FINAL

**Globemaster Corridor Specific Plan
Program EIR/EIS (SCH No. 2018091021)
EIR-03-17**

FIGURE 2-2
Local Context

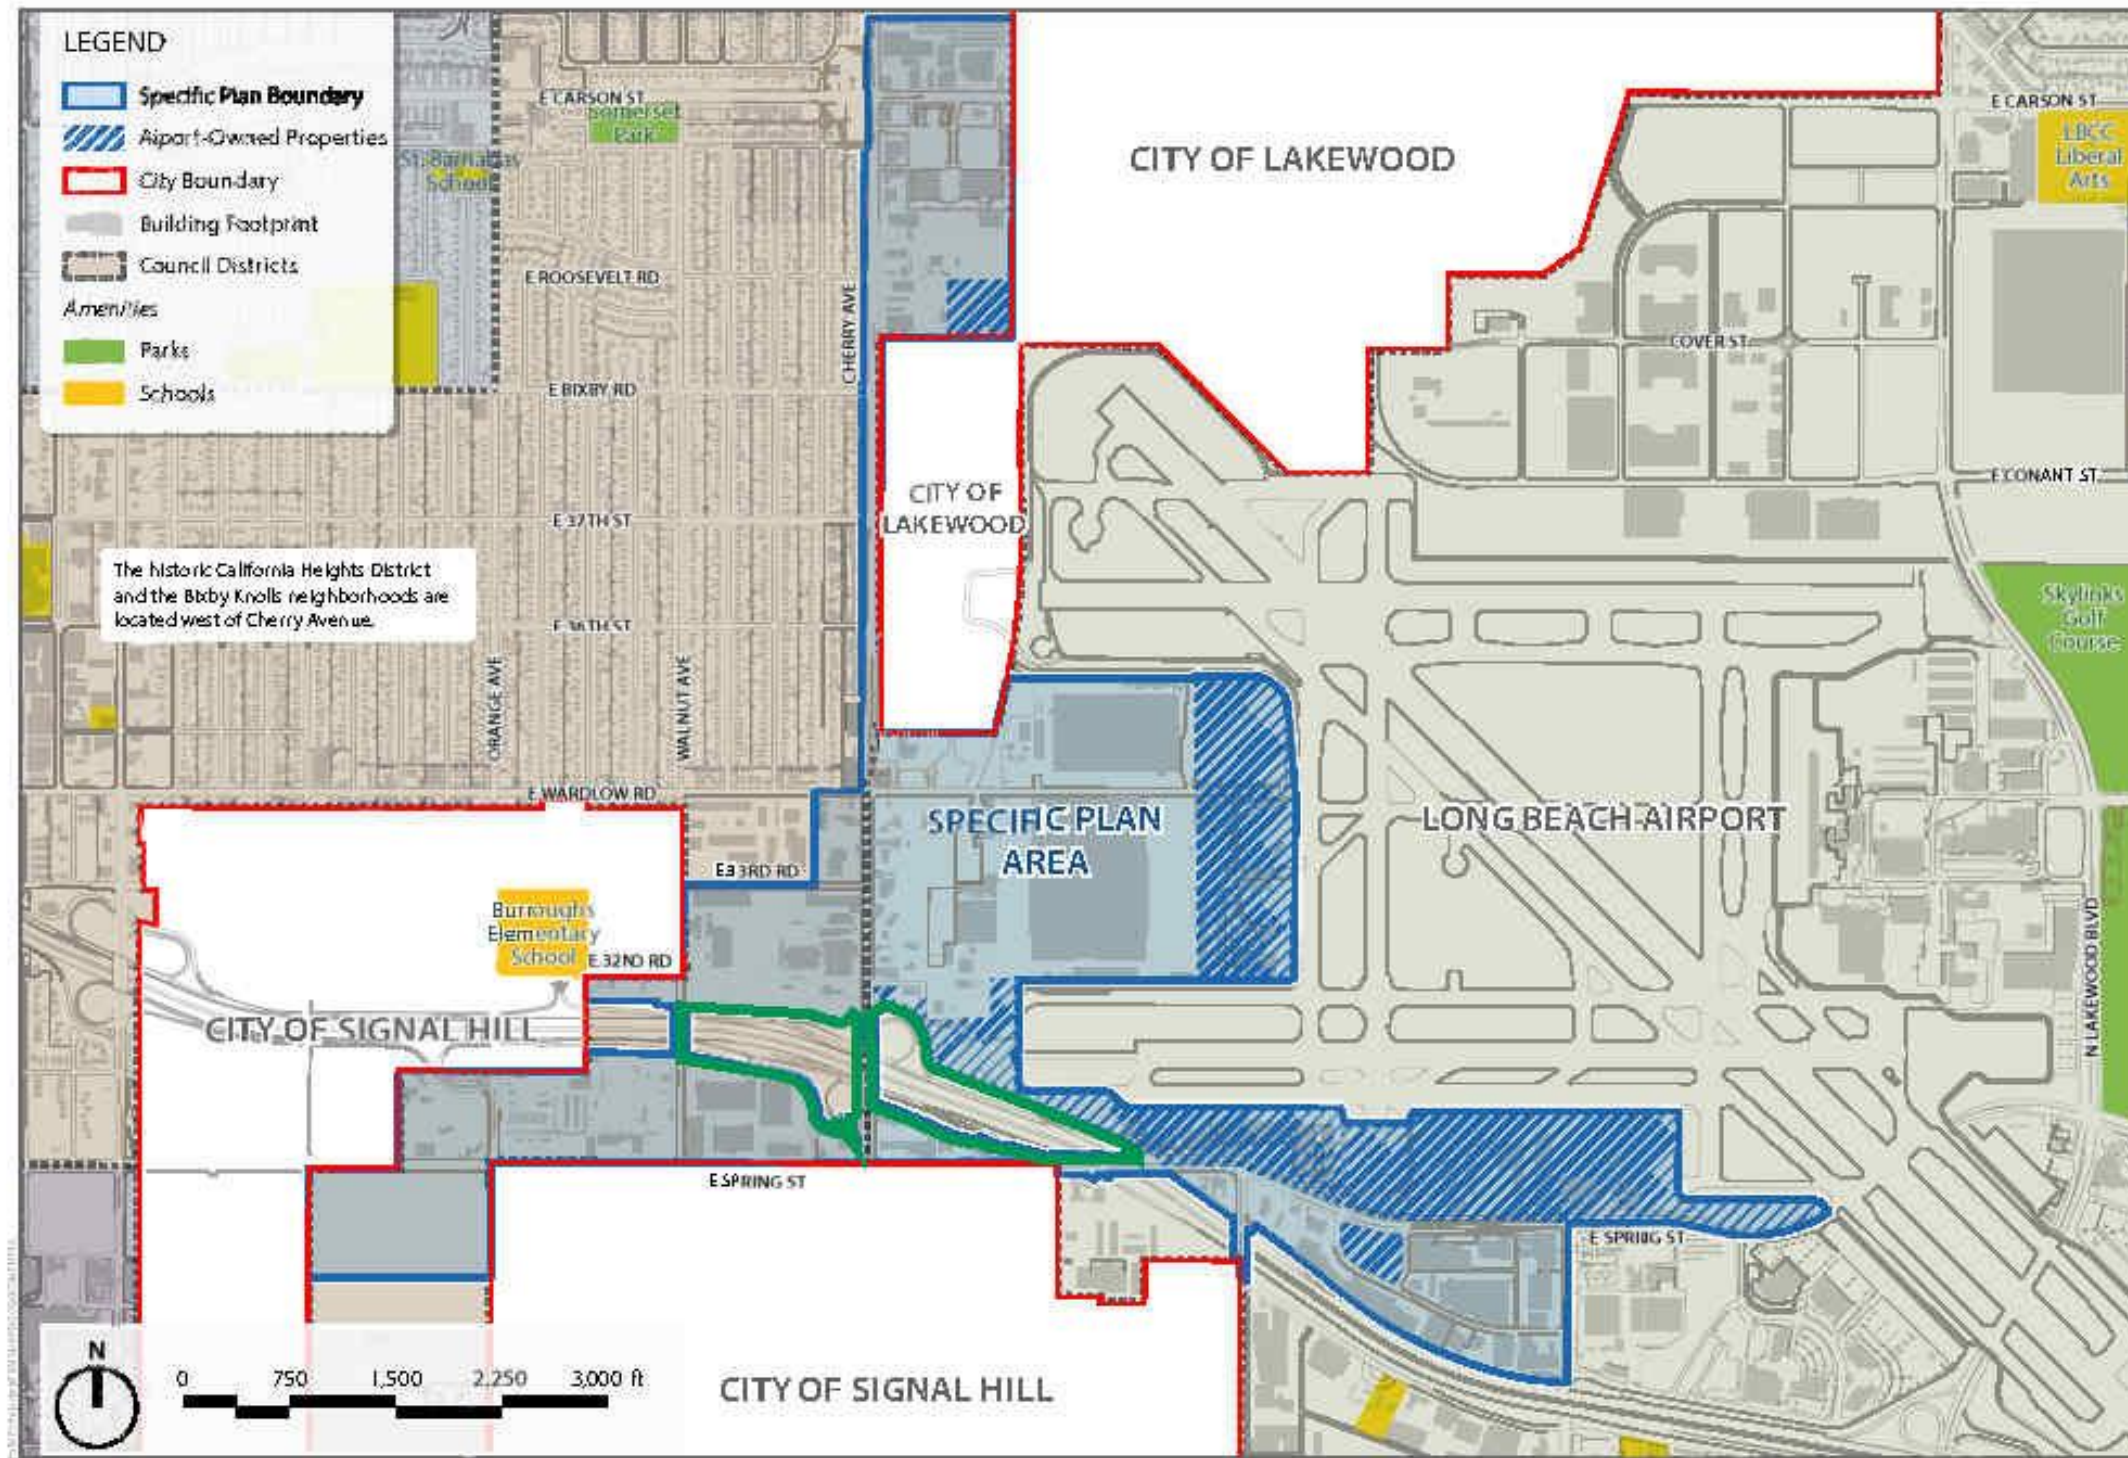
- Figure 2-2 Local Context: An Airport property is not identified in this exhibit. Assessor Parcel Number 7149-010-902 on the south side of Spring Street between Airport Way and Airport Lane is Airport-owned. Please note that this omission appears to only occur on Figure 2-2.

- 5-2** This comment is related to Figure 2-2, Local Context, in Chapter 2, Project Description, of the Draft Program Environmental Impact Report/Program Environmental Impact Statement (PEIR/PEIS). The commenter notes the airport property is not defined in this exhibit. Figure 2-2, Local Context, has been revised to include a portion of airport-owned property located south of Spring Street between Airport Way and Airport Lane that was not identified. Refer to Chapter 3, Changes to the Draft PEIR/PEIS, of this Final PEIR/PEIS.

Figure 2-2, Local Context, has been revised to include a portion of Airport-Owned Property located south of Spring Street between Airport Way and Airport Lane that was not identified in the Draft PEIR/PEIS. See the revised figure

FIGURE 2-9
 Example Development in Business Park District
 Globemaster Corridor Specific Plan Draft PEIR/PEIS

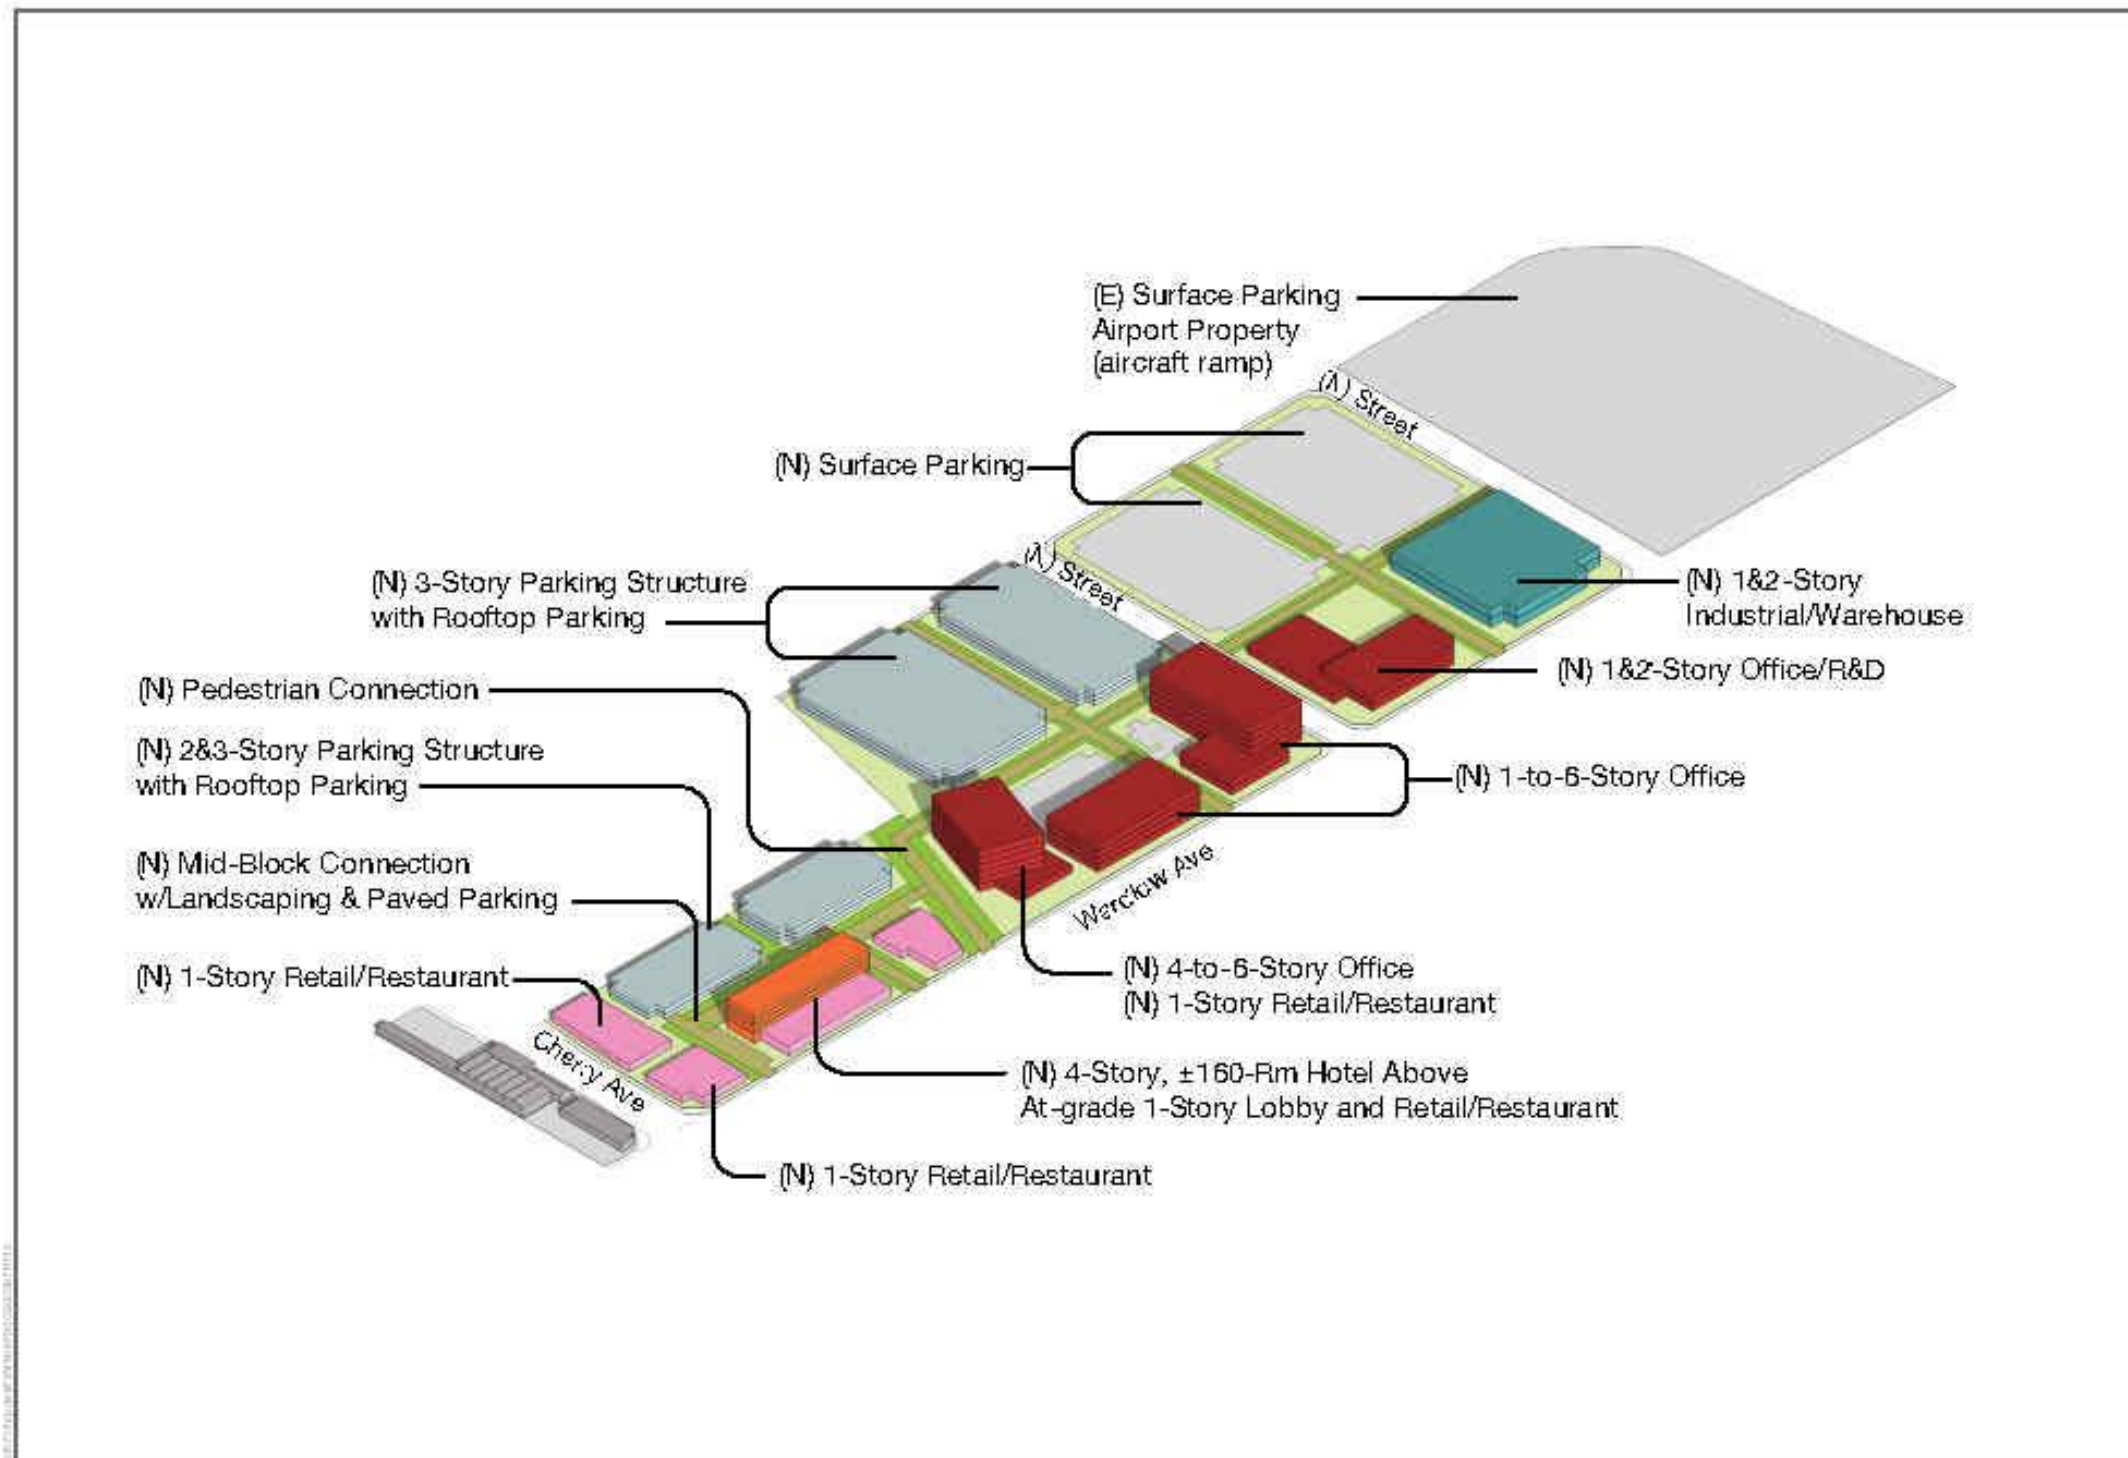
5-4
- Figure 2-8 Example Development in Business Park District: Area (E), Surface Parking, is Airport restricted property for aviation development. It would not be available to support non-aeronautical uses within the Plan Area.

5-5 This comment is related to Figure 2-8, Example Development in Business Park District, in Chapter 2 of the Draft PEIR/PEIS, noting Area E surface parking. The commenter states that this area is airport restricted for aviation development and it would not be available to support non-aeronautical uses. The commenter is correct in that the referenced area is marked as existing “E” surface parking and does not show new potential development because it is within the adjacent Airport District and, as previously mentioned, is reserved for property that is part of the designated airfield of the Long Beach Airport, and adjacent properties under Airport control. To clarify, this section of the figure has been revised to indicate “Airport Property (aircraft ramp)” underneath “(E) Surface Parking”. See the revision in Chapter 3, Changes to the Draft PEIR/PEIS, in this Final PEIR/PEIS.

Figure 2-8, Example Development in Business Park District, has been revised based on a comment provided by the Long Beach Airport to clarify that the area labeled as existing surface parking notes that this area is under Airport control. See the revised figure attached to the end of this chapter of the Final PEIR/PEIS. The proposed revision does not alter the analysis or conclusions presented in the Draft PEIR/PEIS.

FIGURE 3.11-3

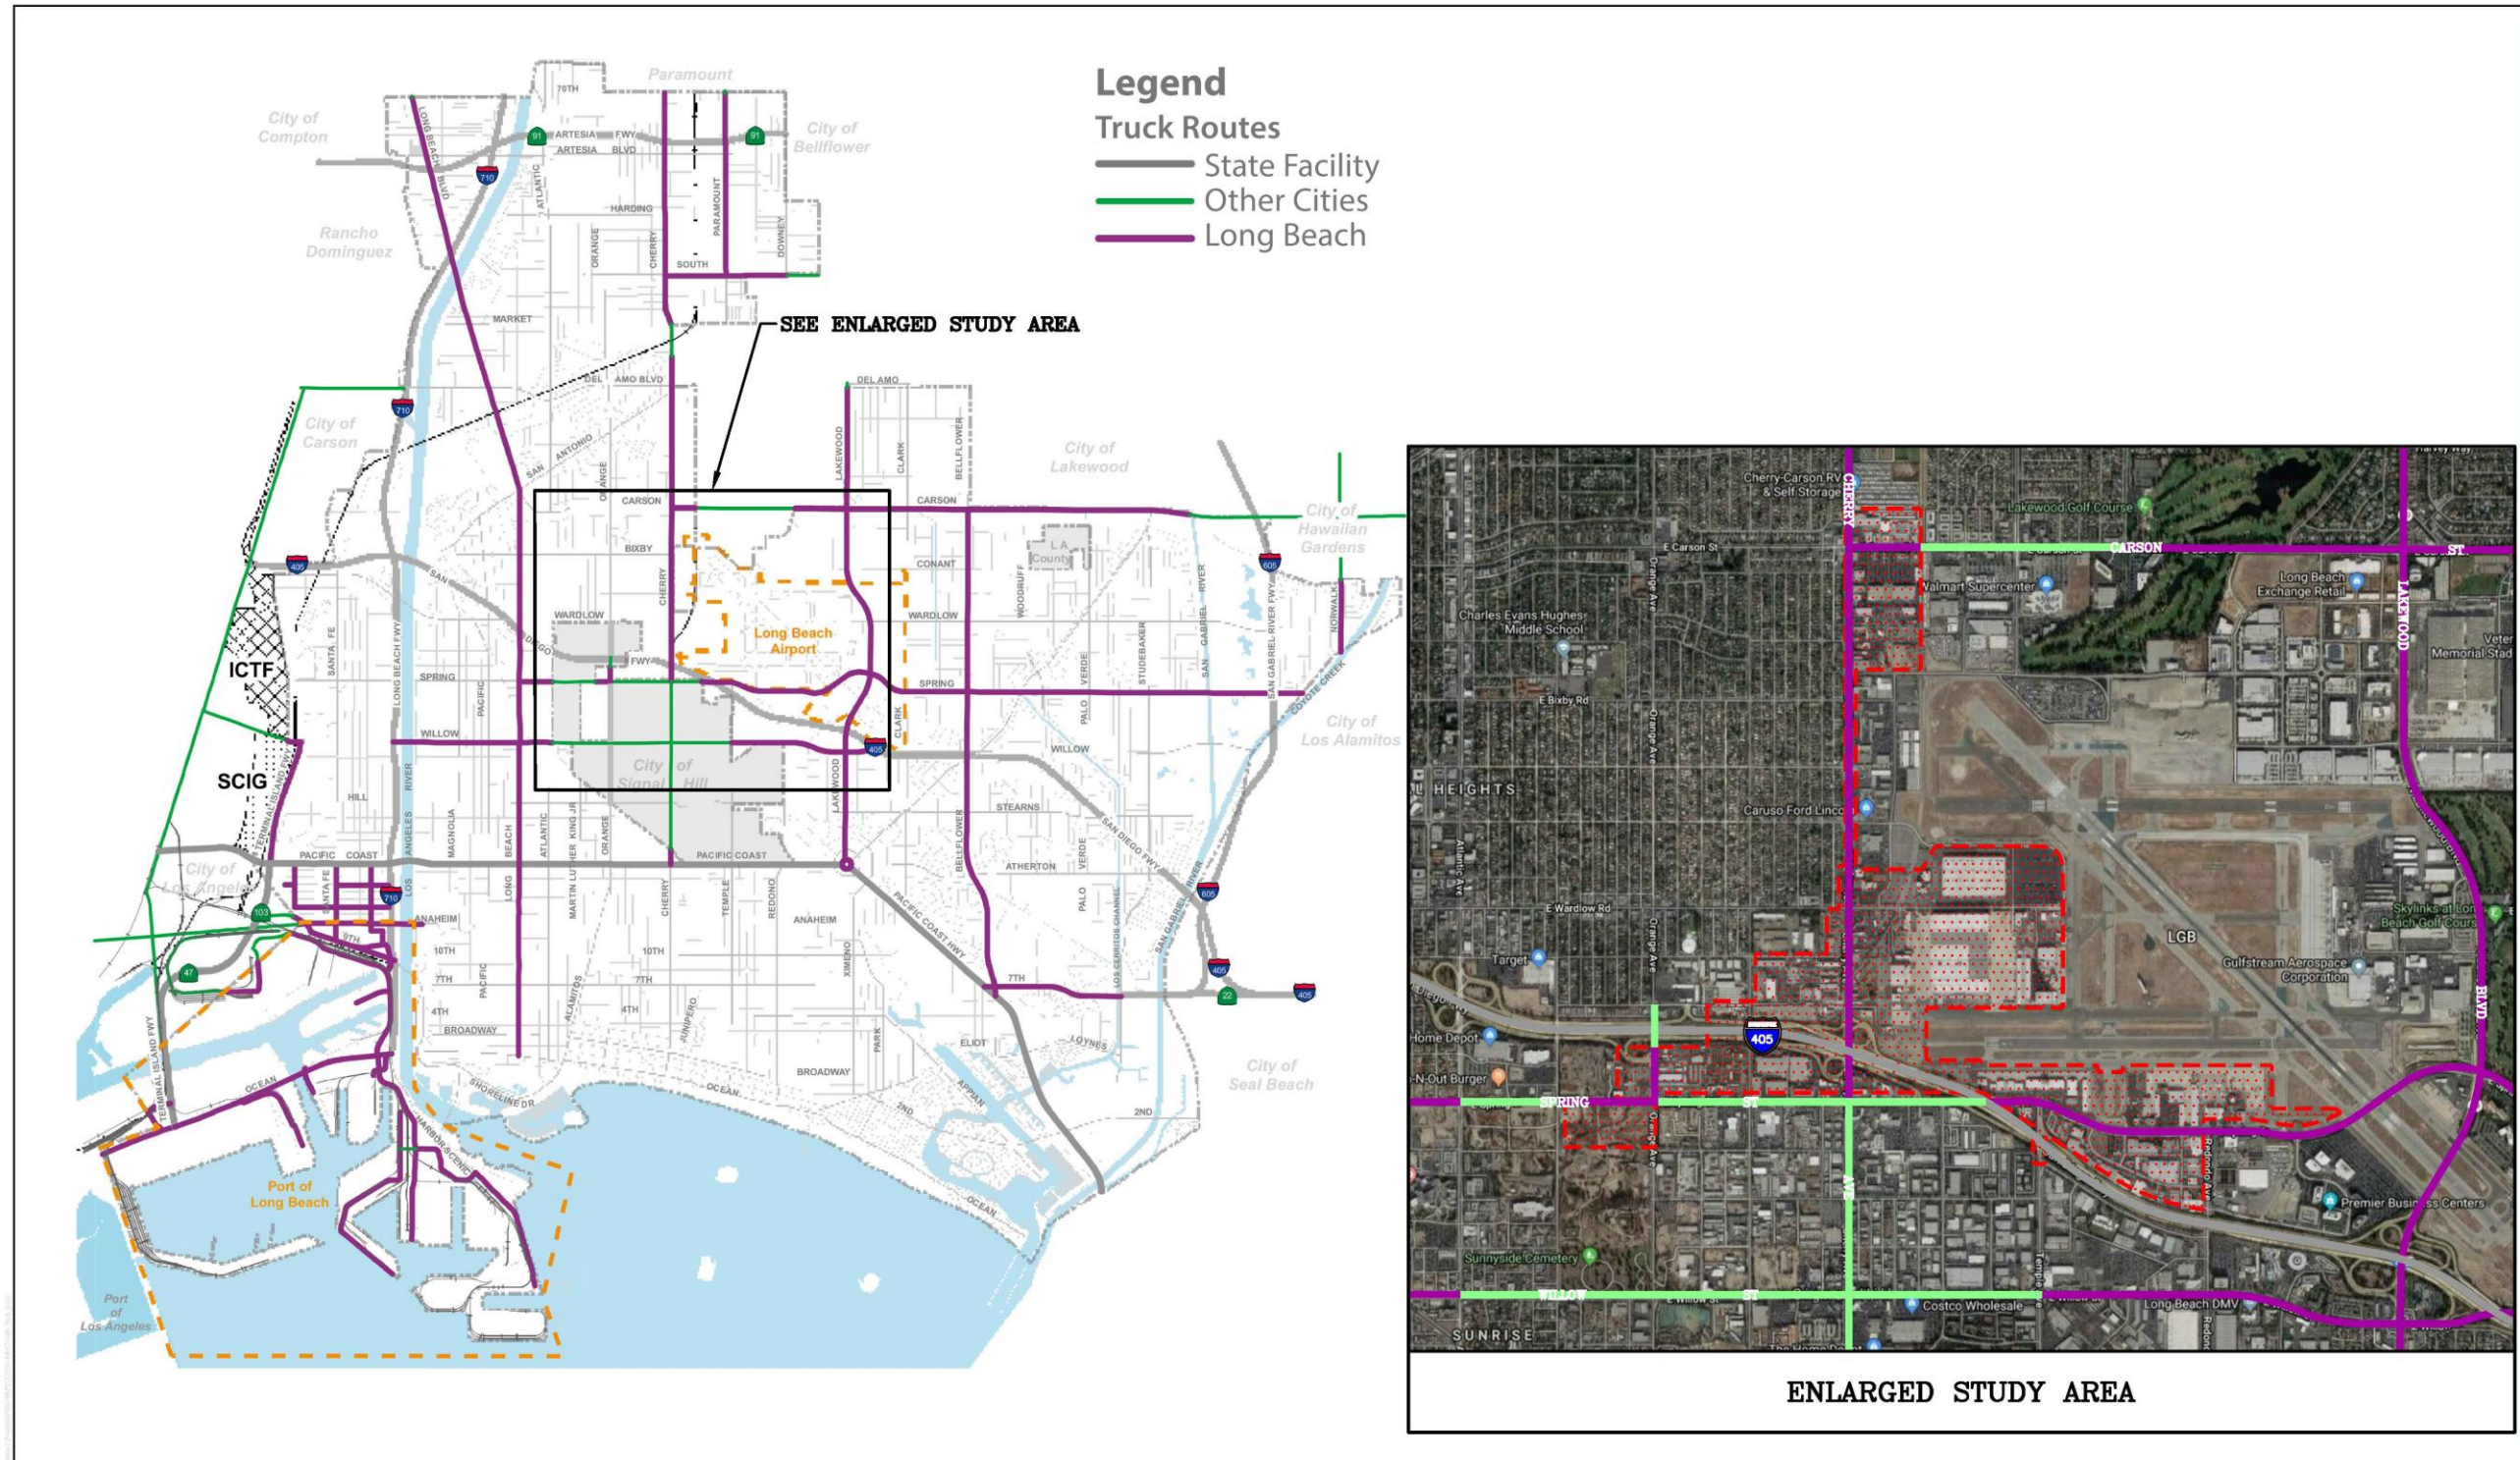
6-8 The comment states that Orange Avenue (from Hill Street to Spring Street and from 32nd Street to Wardlow Road) is not a Truck Route within the City of Signal Hill. Figure 3.11-3, Existing Year 2018 Truck Routes, has been revised in response to this comment. See Chapter 3, Changes to the Draft PEIR/PEIS, of this Final PEIR/PEIS. This revision does not affect any of the evaluation concerning truck

Figure 3.11-3, Existing Year 2018 Truck Routes, has been revised to remove Orange Avenue as a truck route in the City of Signal Hill. See the revised figure attached to the end of this chapter of the Final PEIR/PEIS. The proposed revision does not alter the analysis or conclusions presented in the Draft PEIR/PEIS.
